Addendum 2

RFQMA24 – 5030

Glenforest Secondary School City of Mississauga

Pool Demolition

Graphic Scale	AS SHOWN	Sheet no.
Drawn	Checked	M8
RS	SS	
CAD File	Scale	AS NOTED
Date	Project No.	Revision No.
DECEMBER 2022	23-124

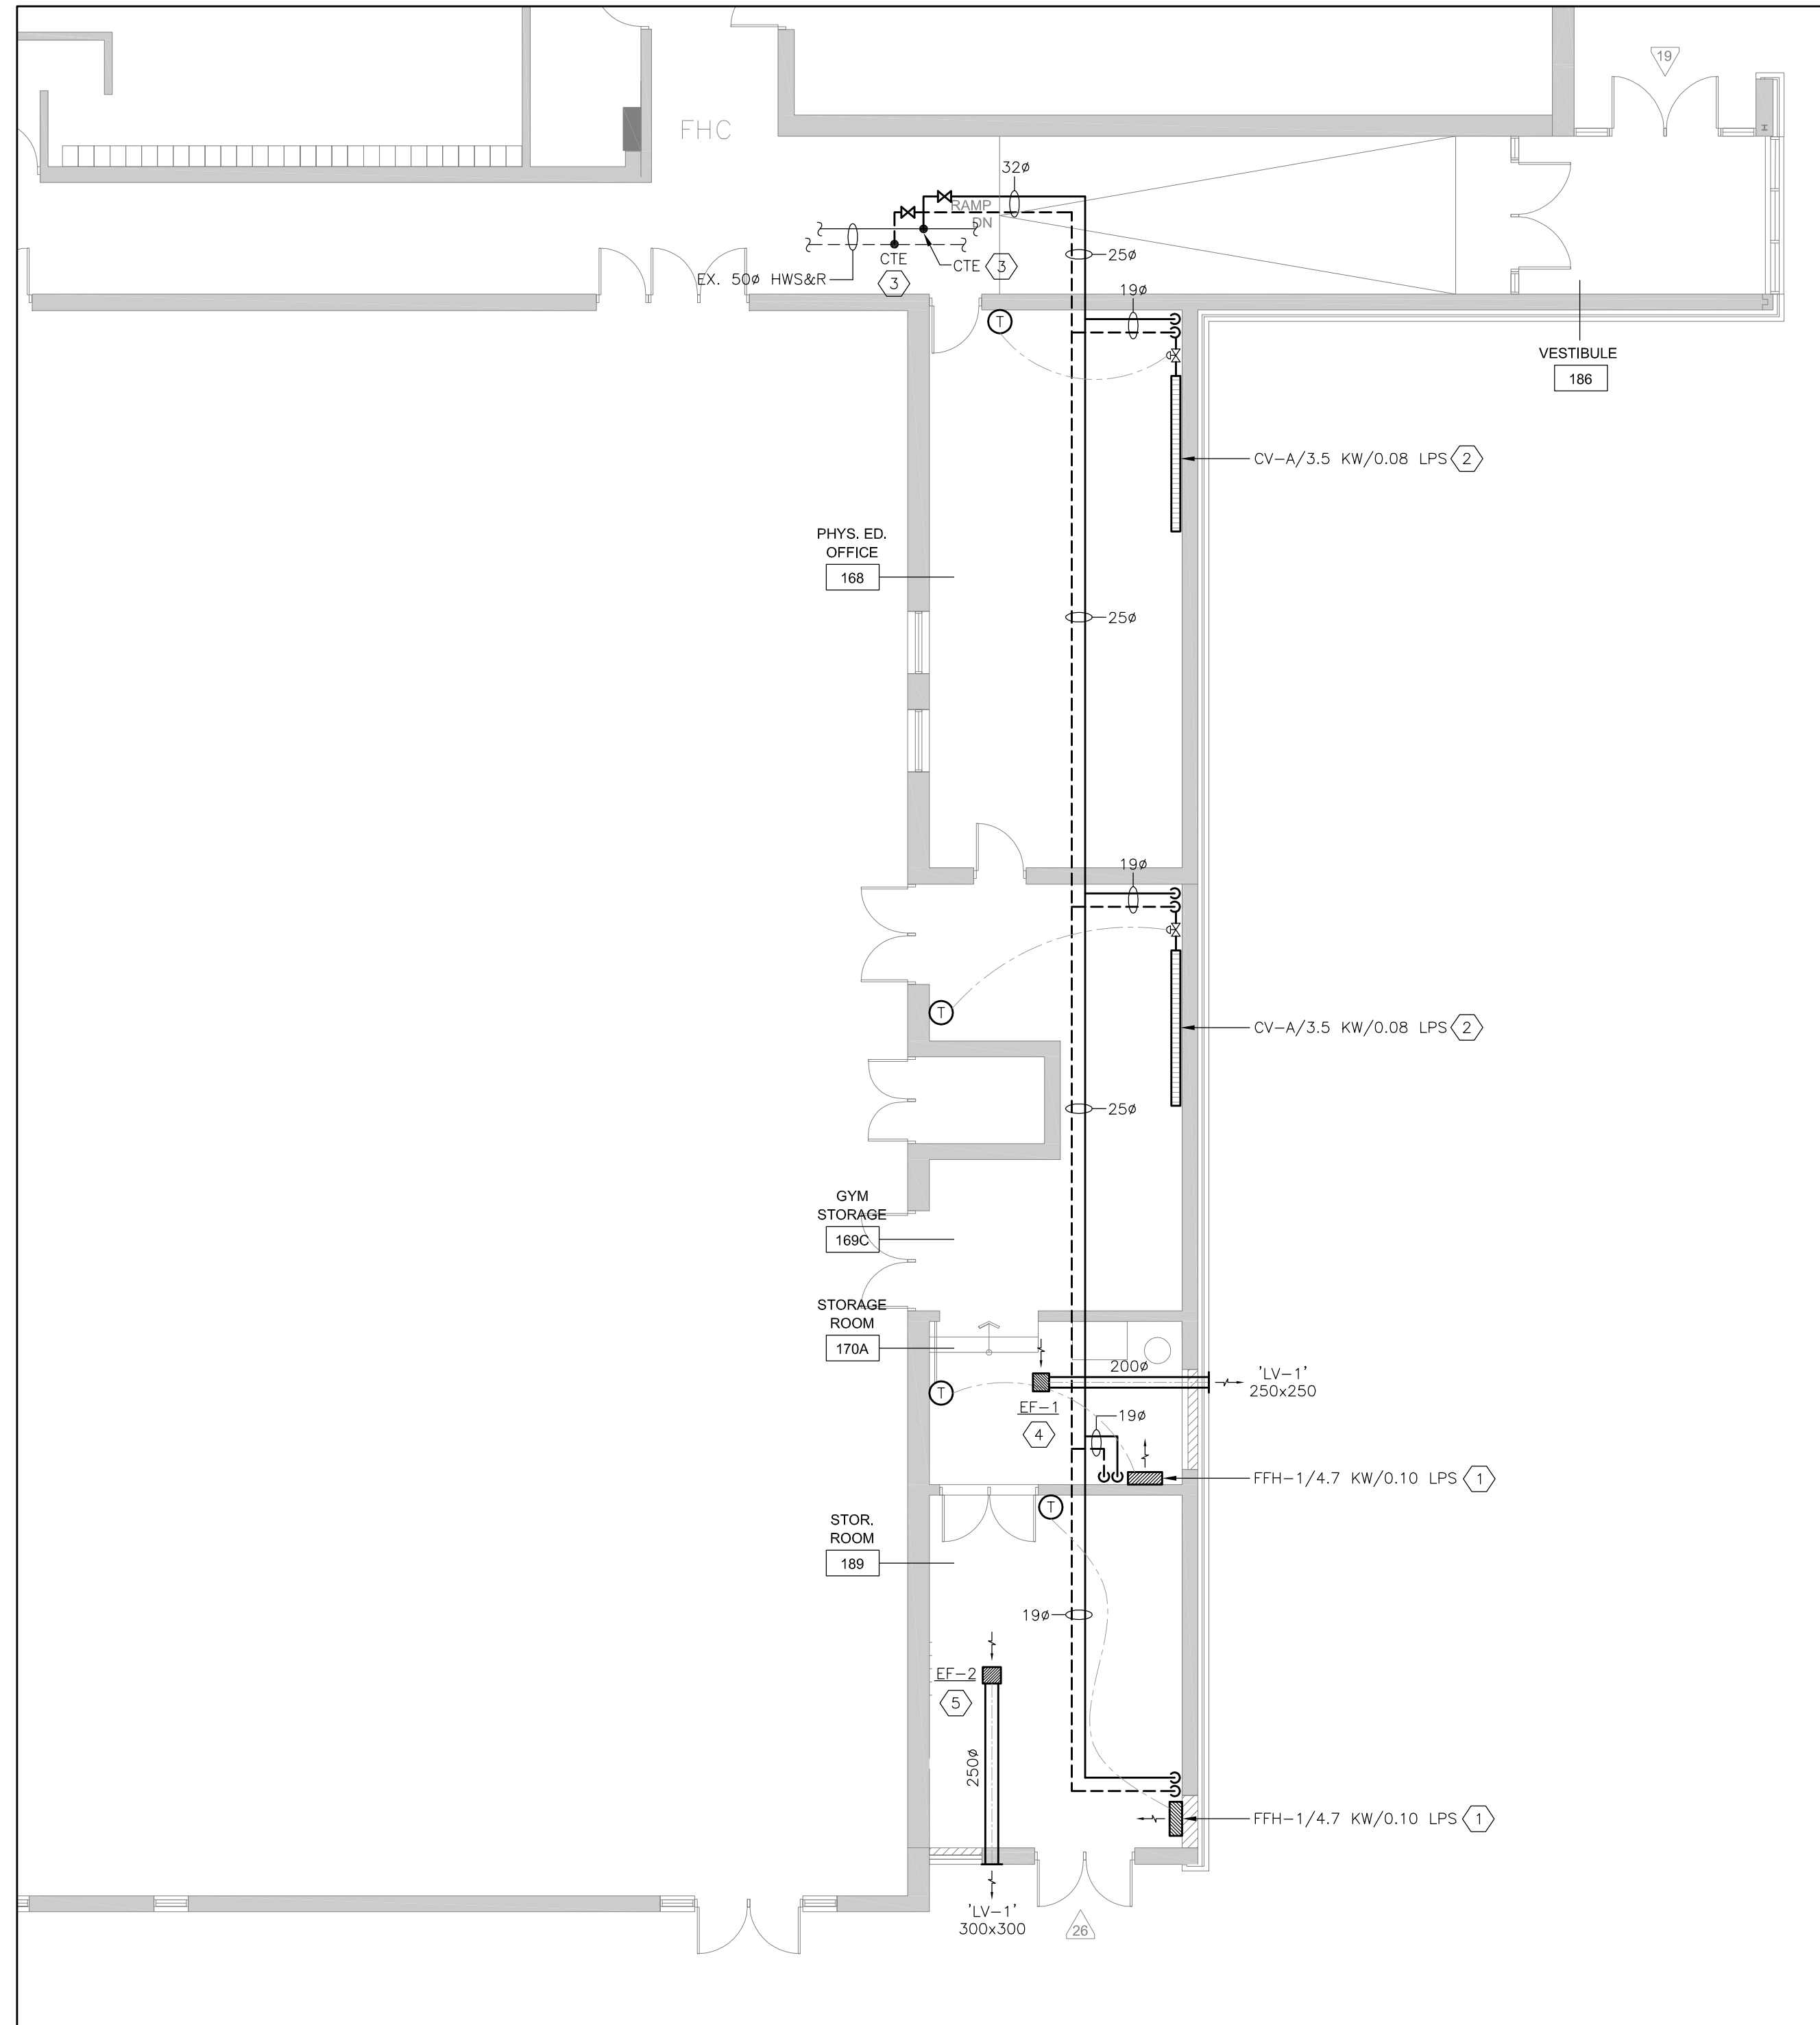
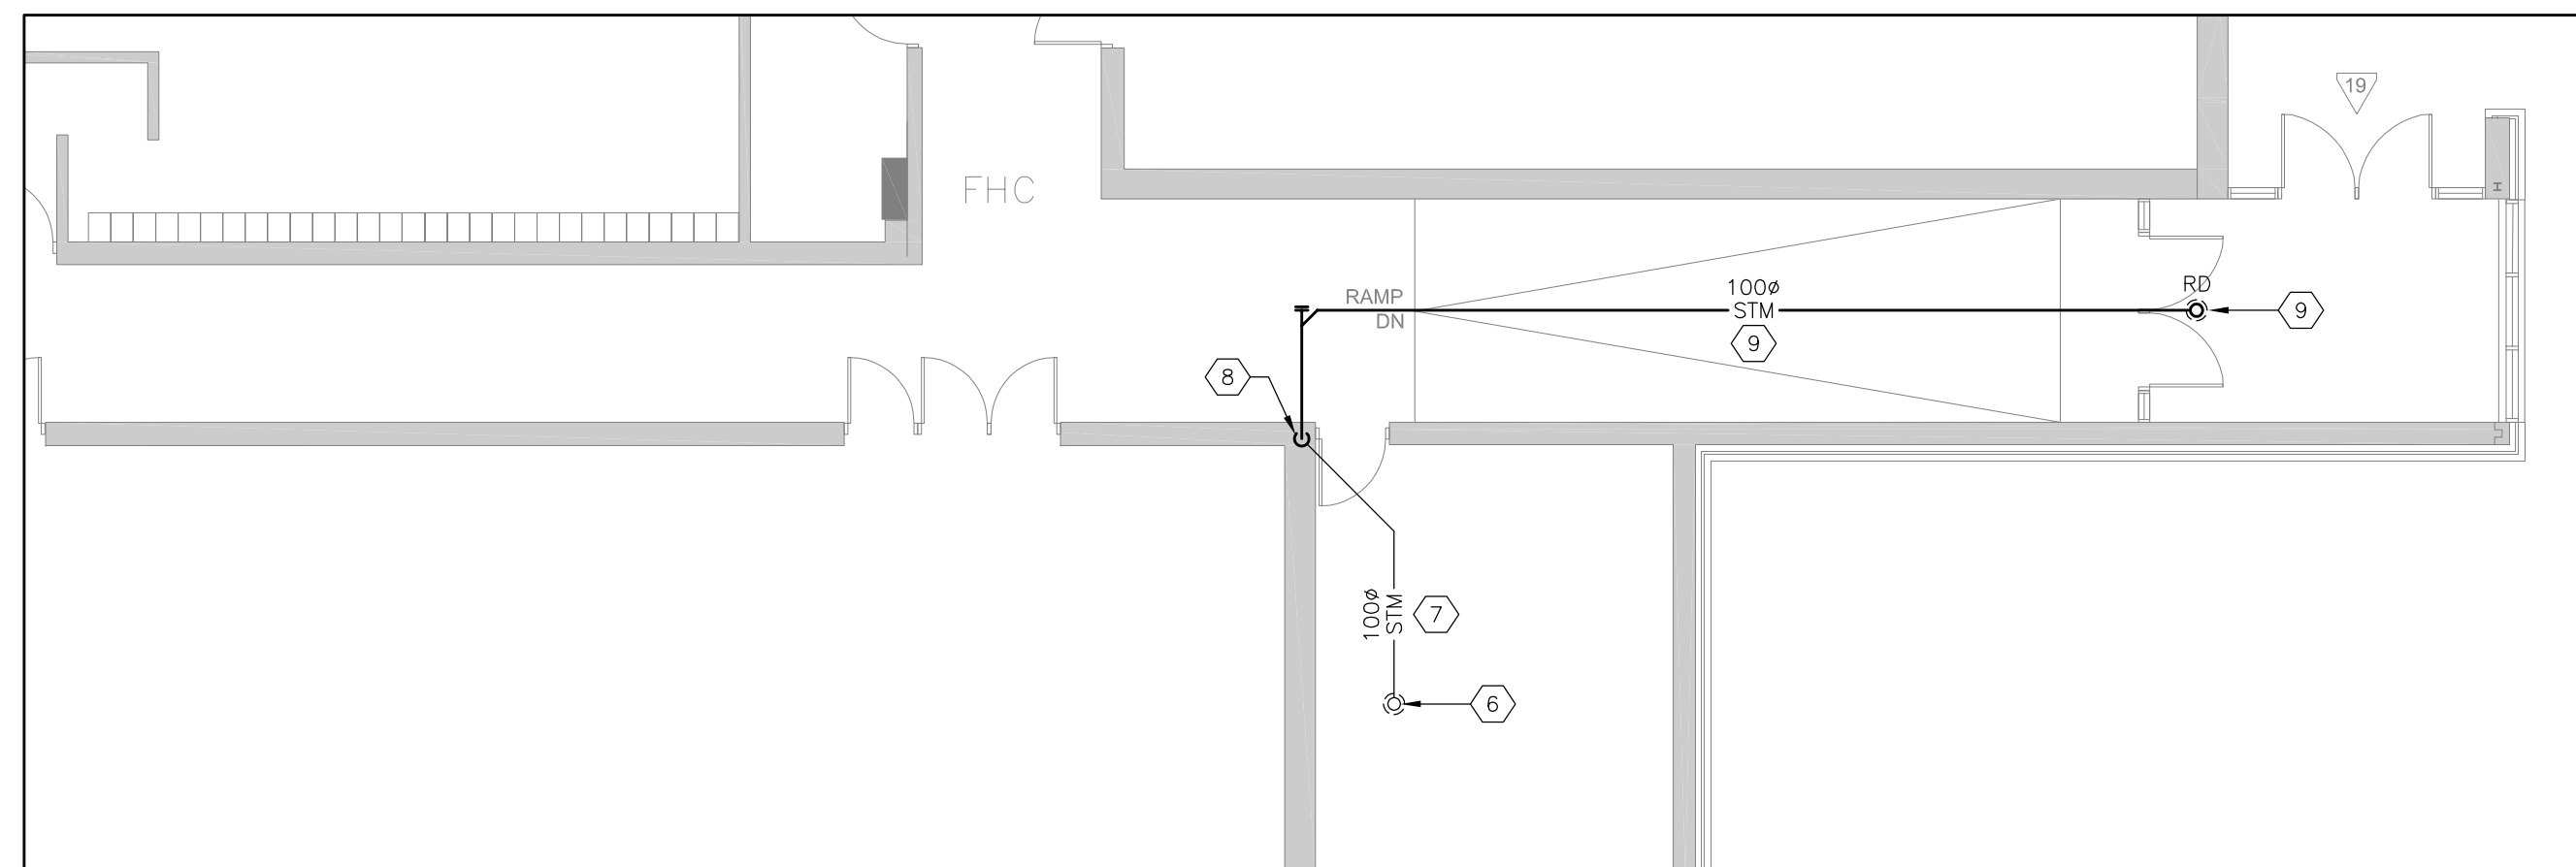
- Response 2: Refer to item 2.2 of this addendum. For temporary irrigation line requirements. GC to review and confirm existing distribution pipe sizing to confirm connections to existing supply valve. Refer to notes 10,11,12 &13 on revised 3/M8.

1. See attached re-issued Drawing with Clouded Revisions.

- 10 PROVIDE NEW 50# DCW PIPING FROM THE EXISTING 100# DCW MAIN IN THE CORRIDOR CEILING SPACE TO THE NEW IRRIGATION CONTROL BOX IN THE GYM STORAGE ROOM.

- 11 PROVIDE A NEW PRV AND BACKFLOW PREVENTER AT THE LOCATION OF THE RELOCATED IRRIGATION CONTROL BOX.

- 12 PROVIDE NEW UNDERGROUND 50# IRRIGATION LINE FROM THE GYM STORAGE ROOM AND CONNECT TO THE EXISTING UNDERGROUND IRRIGATION LINE AT THE PERIMETER OF THE EXISTING POOL BUILDING. SITE VERIFY LOCATION. APPROXIMATE LENGTH OF PIPING IS 45 METERS.
13. RELOCATION OF THE IRRIGATION CONTROL BOX, PROVISION OF POWER CONNECTION AND SUPPLY/INSTALL OF THE NEW BACKFLOW PREVENTER AND PRV AND SUPPLY/INSTALLATION OF THE NEW 50# DCW LINE TO THE NEW IRRIGATION CONTROL BOX LOCATION SHALL TAKE PLACE AT THE ONSET OF THE PROJECT. SEE ARCHITECTURAL DRAWING FOR ROUTING OF A TEMPORARY IRRIGATION LINE (ABOVE SURFACE) FOR THE DURATION OF CONSTRUCTION TO MAINTAIN CONTINUITY OF THE IRRIGATION SYSTEM DURING CONSTRUCTION. PROVIDE HEAVY-DUTY HOSE CAPABLE OF SERVICING THE IRRIGATION SYSTEM.
